UCRL-ID-130551

Livermore Big Trees Park 1998 Soil Sampling Plan

October 1998

Figure 2. Locations sampled in 1995.

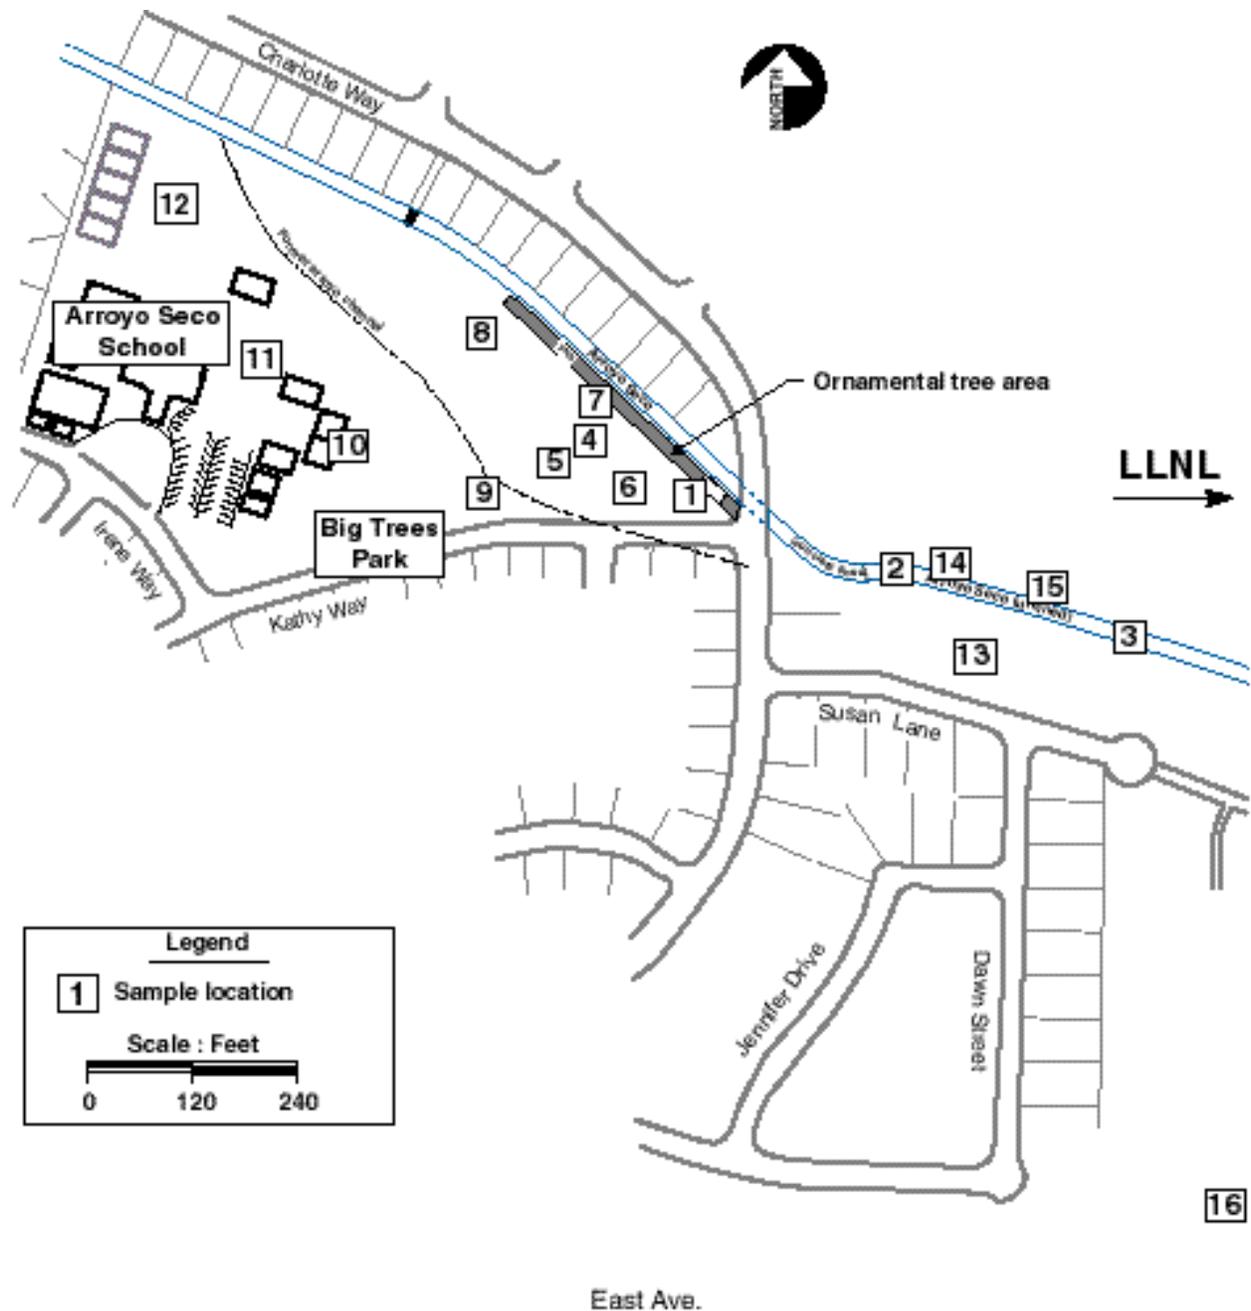
Comment 18. *Section 2.1, pages 4, 5. This section should include a reference to Figure 1 and identify the location of the area that will not be resampled.*

Comment 48. *Figure 1, Proposed Resampling of 1995 sample locations. The figure shows numbered sampling locations, however, it does not depict samples 16 through 19; it is recommended that these locations be explicitly depicted.*

Comment 2. *Clarification of sample selection.* [Section 2.1 Resampling of January 1995 sampling locations (pp.4-5) and Appendix A Concentration Depth Profile Examples (p.25). 1st paragraph of section, 1st sentence, "Samples will be collected at all locations that were sampled in 1995..."] 2nd paragraph of section, "Subsurface samples at increasing depths will be collected at each location" The sampling plan states that samples will be collected from 3 depth intervals, and Figure 1 shows 16 proposed (re) sampling locations, for a total of 48 samples. The sampling plan states that 19 samples are planned for this area, not 48, as implied by the text. CDHS is requesting clarification regarding this issue. It is unclear which samples overlap, also. An additional map should be provided with ALL proposed sample locations represented.

Figures are now referenced in appropriate sections of the Draft Final Livermore BTP 1998 Soil Sampling Plan. All sample locations from the 1995 study are now shown on Figure 2 of the Draft Final Livermore BTP 1998 Soil Sampling Plan; however, only locations 1, 7, and 8 will be resampled.

The 1995 sampling consisted of 19 samples from 16 locations (four samples were collected from location 1). Location 16 from the 1995 study was outside the area shown on Figure 1 of the draft BTP Sampling Plan. Figure 2 of the Draft Final Livermore BTP 1998 Soil Sampling Plan shows all 1995 sample locations; Locations 1, 7, and 8 will be resampled in this study.

Figure 4. Sampling area in the old Arroyo Seco.

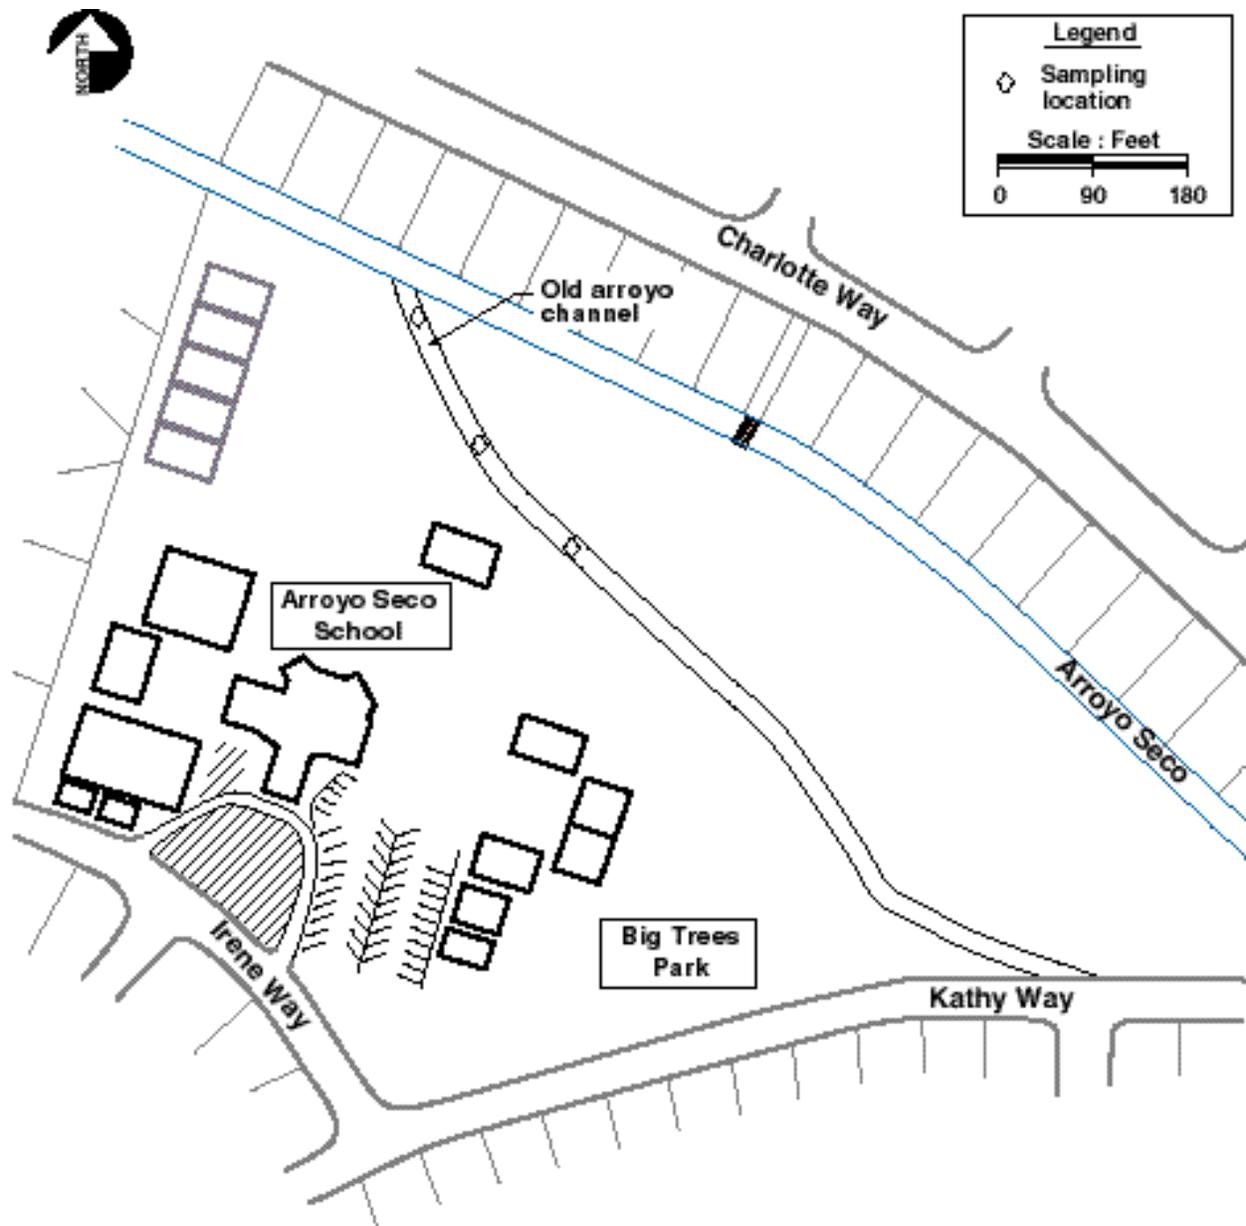
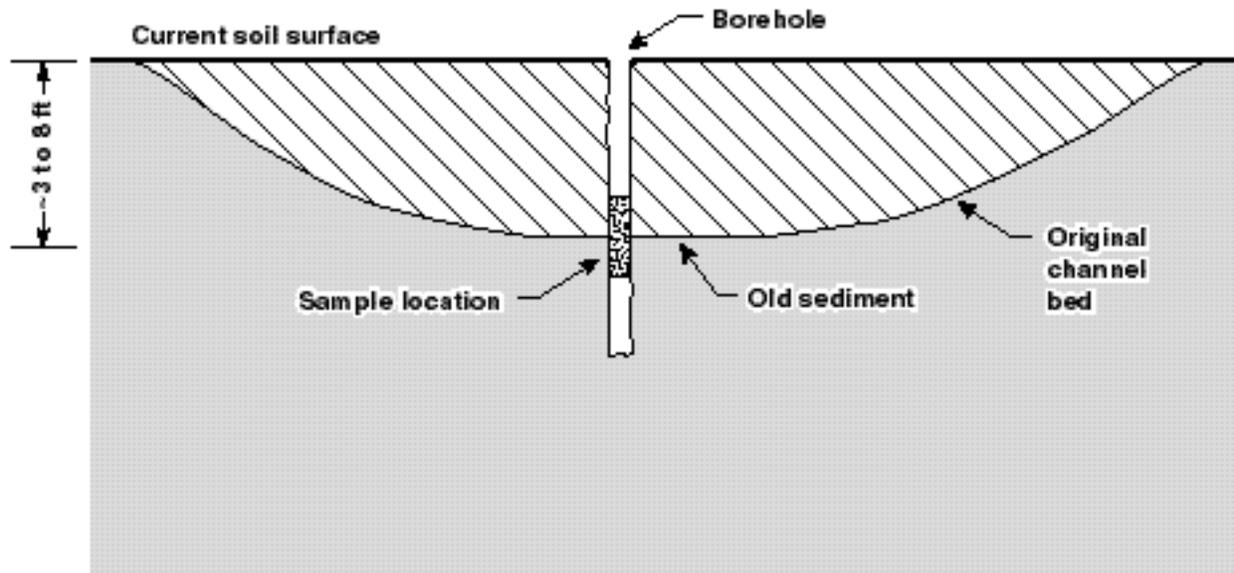
In Subset 2, the location of samples in the former Arroyo Seco channel is described. This section should reference Figure 3.

Sample locations in the former arroyo are now discussed in Section 3.1.1 and shown on Figures 4 and 5 Draft Final Livermore BTP 1998 Soil Sampling Plan.

Figure 7. Grid sample locations.

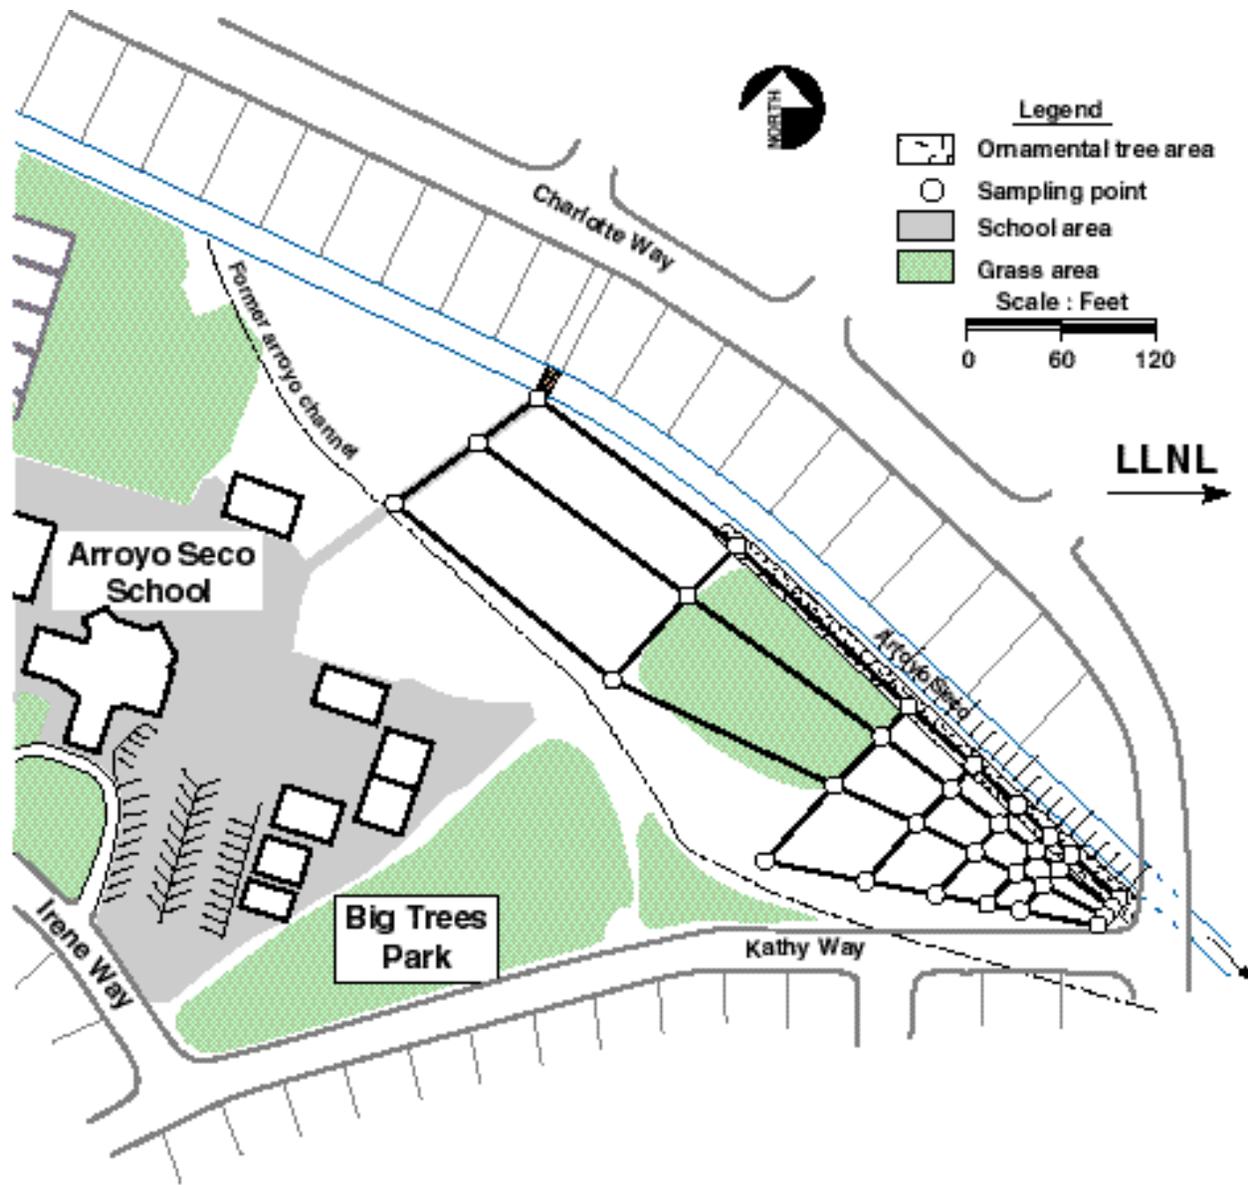
Comment 22. *Figure 5 of the sampling plan. This figure should be replaced by one that shows the exact sampling locations on the grid. It is understood that the samples will occur at the nodes of the grid. The nodes should be marked explicitly and the sample locations given an*

Figure 7 in the Draft Final Livermore BTP 1998 Soil Sampling Plan now clearly indicates that the sample locations are at the grid nodes. The sample location identifiers are described in the Field Sampling Procedures (Appendix C of the Draft Final Livermore BTP 1998 Soil Sampling Plan).
